September 22, 2023

ADDENDUM NO. FIVE (5)

PROJECT: PV-TEC Building Remodel

**1 DEMOLITION FLOOR PLAN**  
**A2.1**  
 1/16" = 1'-0"  
 NORTH

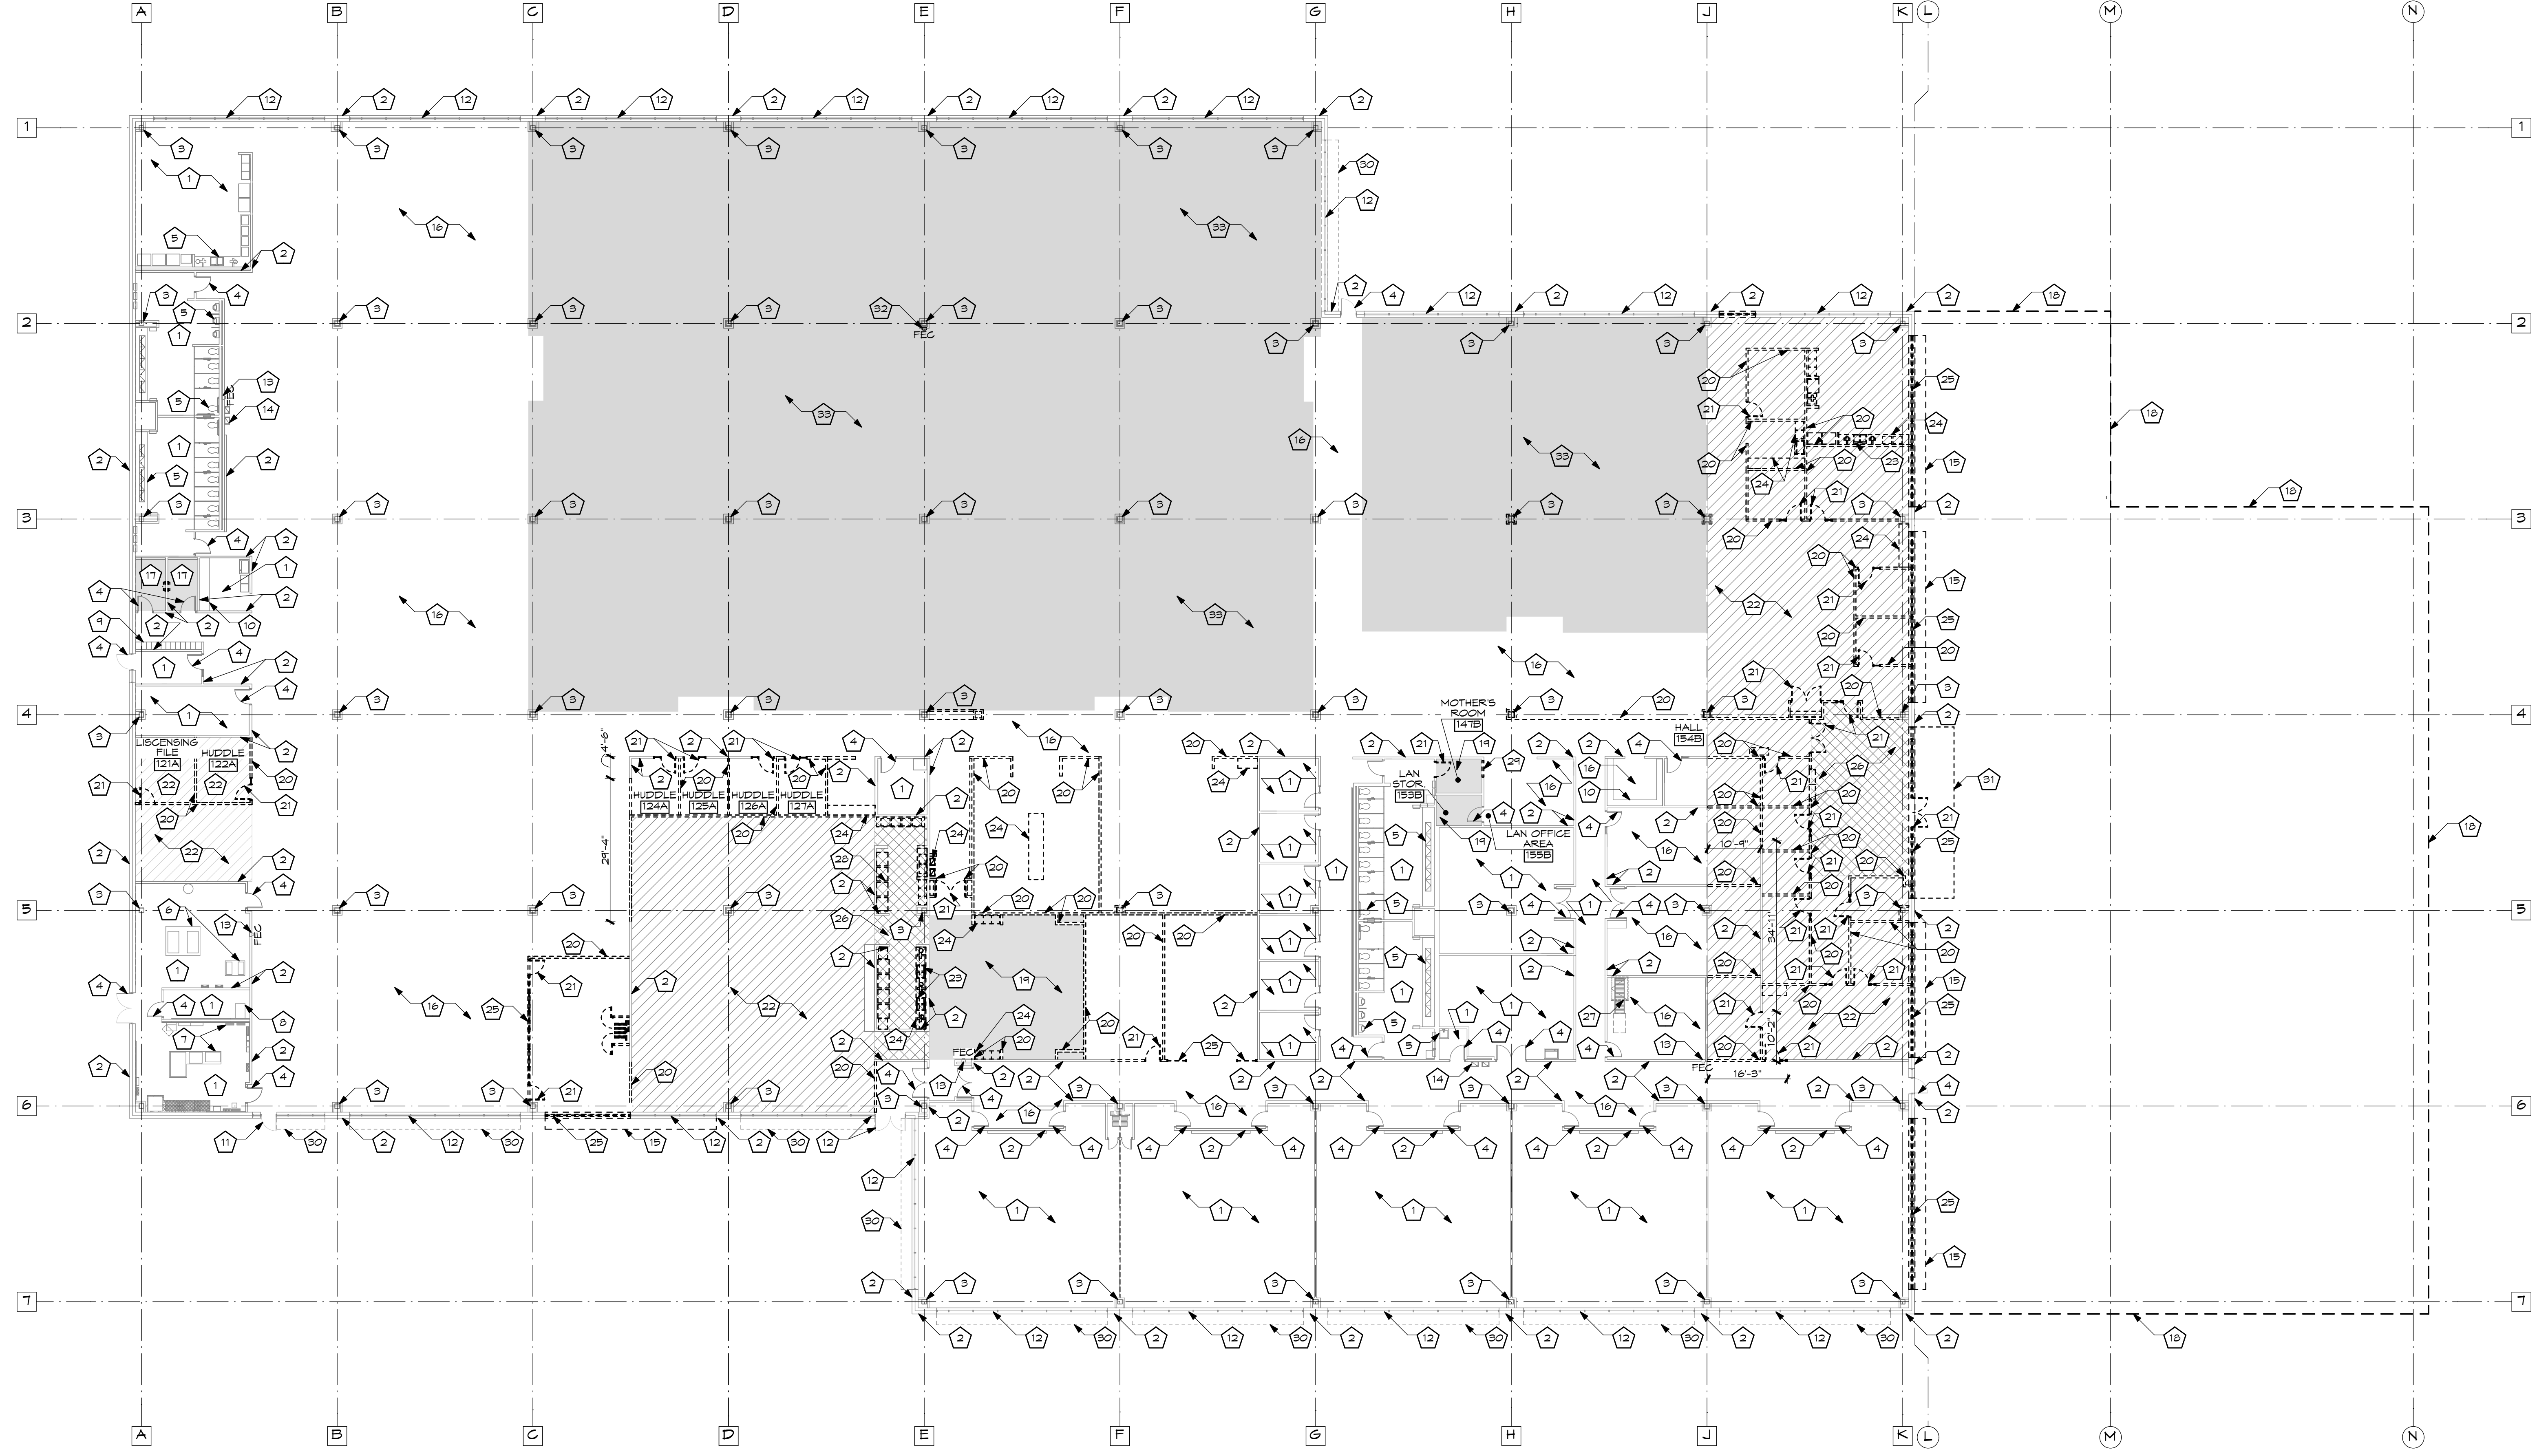
D1 A2.1 – At the new classroom locations, the flooring finish shall be new 24x4 carpet tile. The demolition plan (attached) has been updated to show the existing carpet is to be removed and salvaged for potential reuse at these new classroom areas. Keyed note 33.

| 6 (E) MECH. EQUIPMENT TO REMAIN - REFER TO MECH. SHEETS      | 16 (E) RAISED FLOORING AND CARPETING TO REMAIN   | 25 (E) STOREFRONT TO BE REMOVED AND DISCARDED  | 33 (E) CARPET TO BE REMOVED AND SALVAGED FOR REUSE                                      |

DATE: JUL 23  
 DRAWING NO. **A7.1**  
 JOB NO. 2306  
 23 OF 49

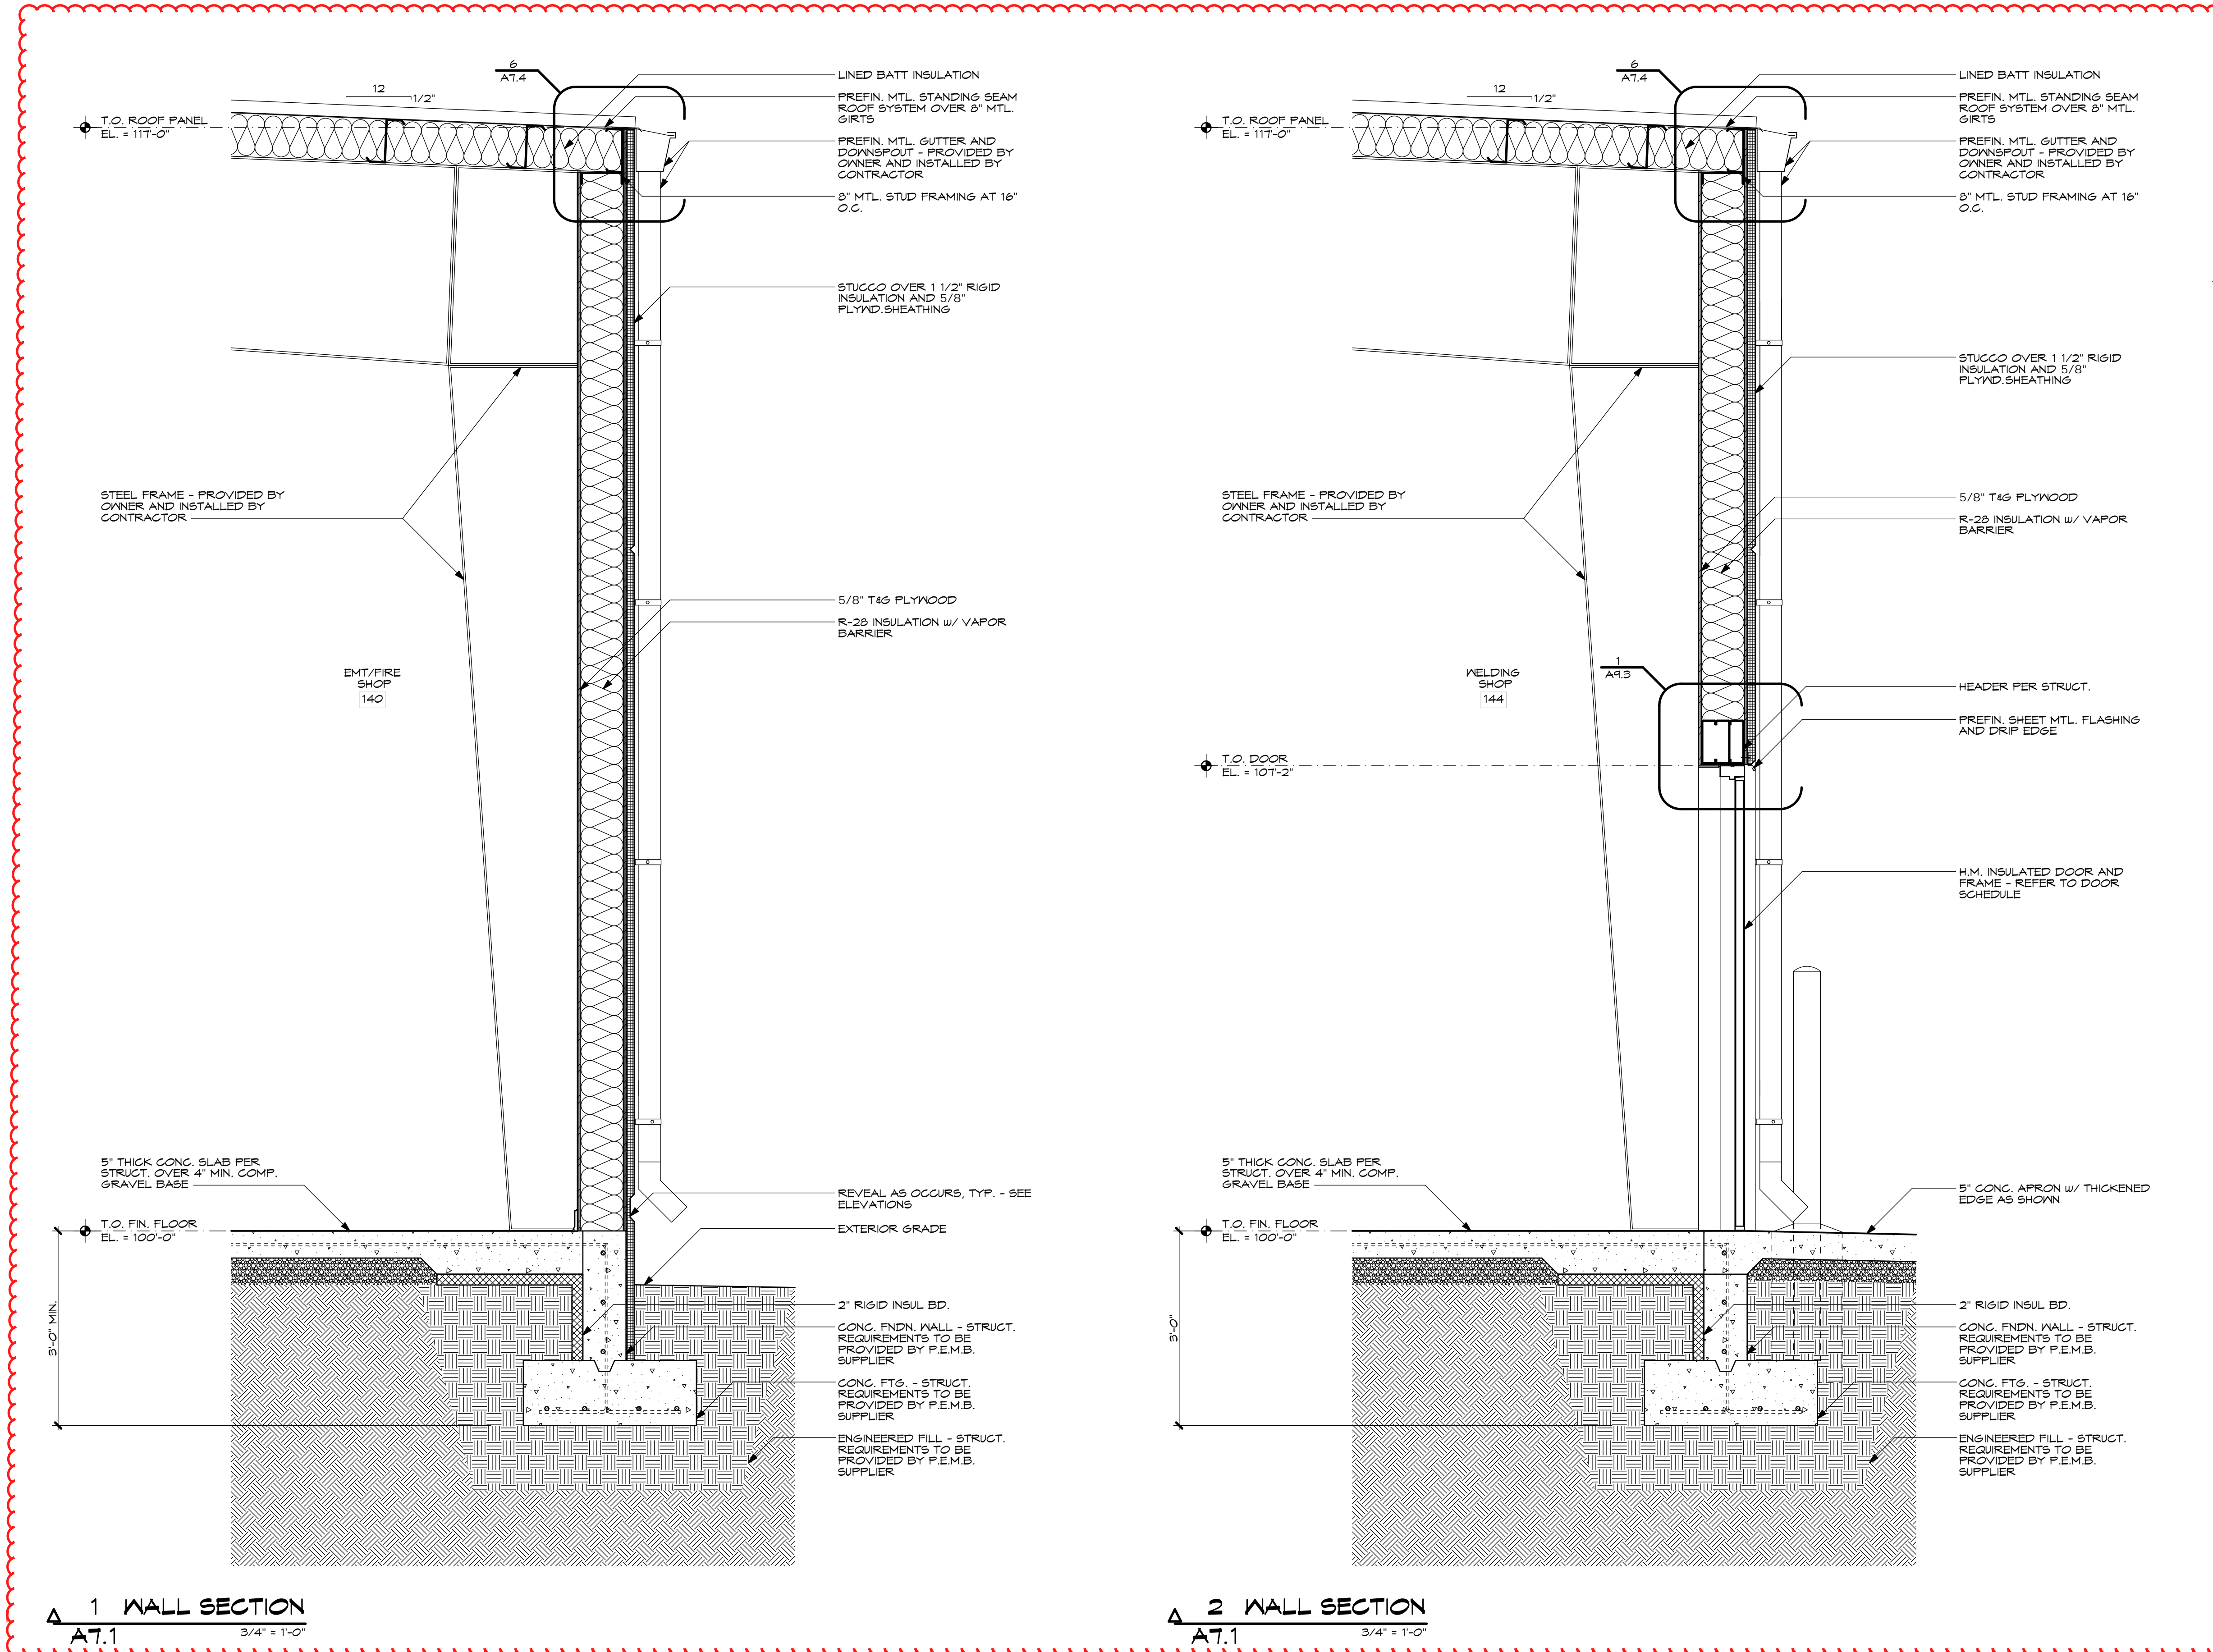
- D2 A7.1, A7.2 - Please see section details without girts to reflect there will NOT be any girts within exterior walls of addition.
- D3 A8.1, A8.2 – As a matter of clarification, the exposed structural framing and columns within the new building addition shall NOT be painted.
- D4 A8.1, A8.2 – As a matter of clarification, the sealed concrete shall comply to the following:
- Concrete Sealer: High-performance, non-yellowing, clear acrylic-based sealer  
Finish: Matte Finish
- D5 E2 Sheets – The “EX” labeled next to the fixtures in the ceiling are existing fixtures.
- D6 E6.1 – Provide and install line voltage (120 or 277) to each wireless light control. See attached sketch
